# Cooling System Surge Tank and Mounting Bracket Revisions

M-261-005

(March 2009)

Mack CHU, GU models built before September 2007

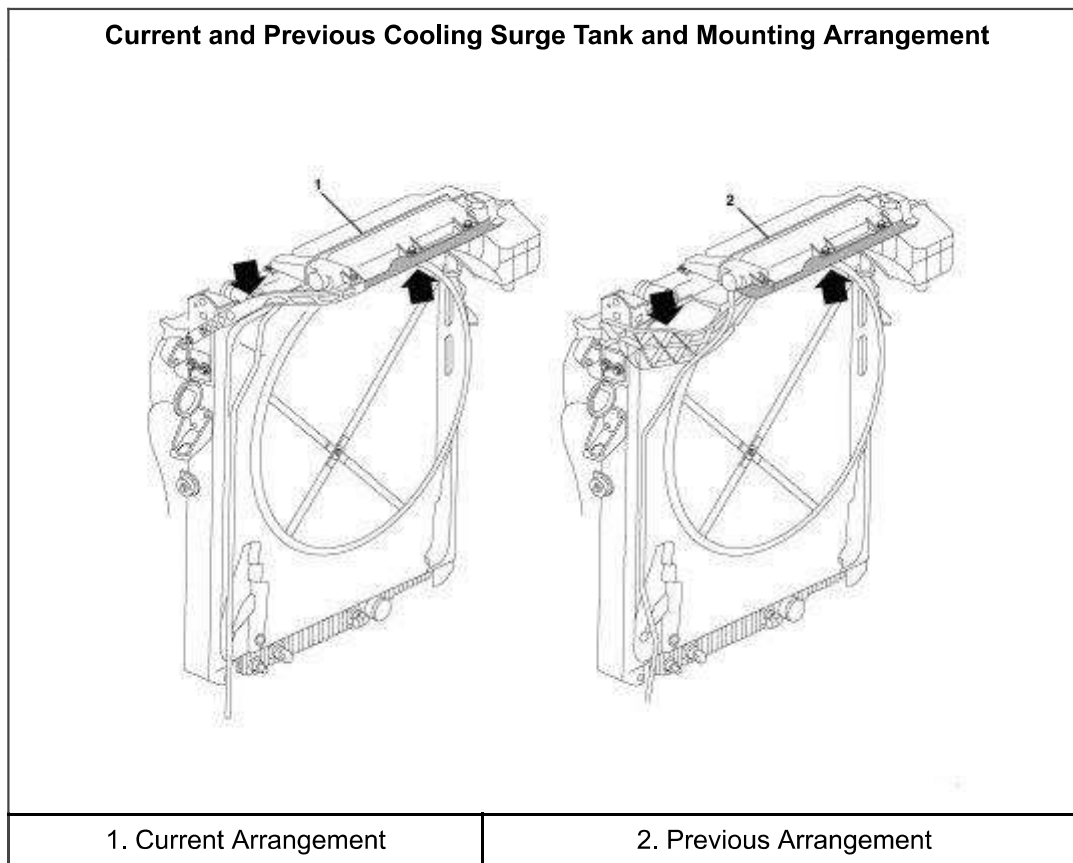
Effective September 10, 2007, a revised cooling system surge tank (part number 21074555) and mounting arrangement were implemented into production on all CHU and GU model chassis, replacing the previous surge tank part numbers 76MF526M and 76MF528M. The differences between the previous and current surge tank and mounting arrangements are shown in the following illustration.

| <b>Revised Cooling System Surge Tank and Mounting Arrangement</b> |

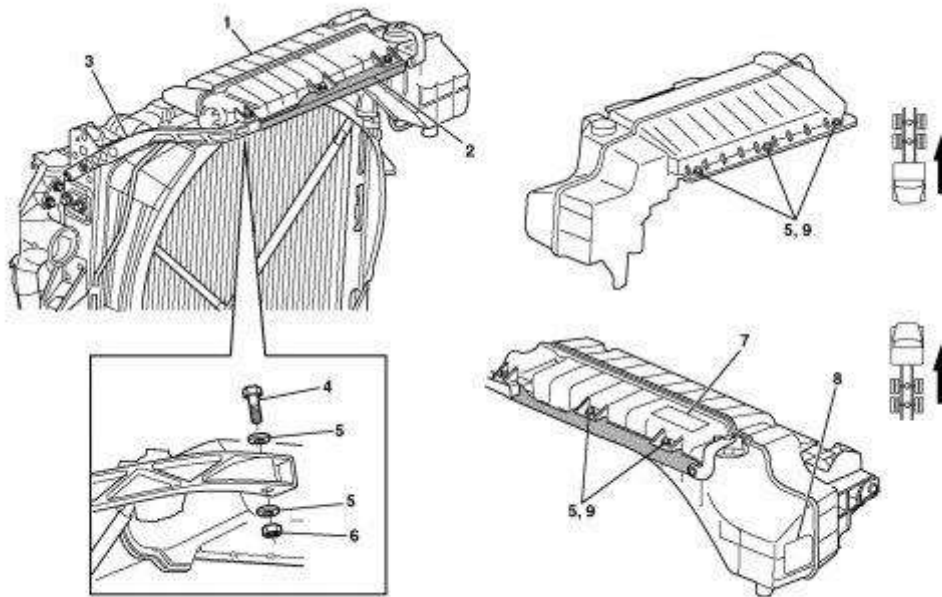
Should a surge tank require replacement on a CHU or GU model manufactured prior to September 10, 2007, the following mounting brackets and hardware will be required.

*Note: The mounting screws used at the front of the surge tank are 20 mm long. Be sure to use the correct screws. Using screws longer than 20 mm will damage the radiator upper tank.*

*Note: Effective November 10, 2008, the flanged mounting screws with captive washers (part number 971381) were replaced in production by prevailing torque mounting screws (part number 949853) and separate washers (part number 976944). Prevailing torque-type screws are one-time use only, and must be replaced with new screws anytime they have been removed.*
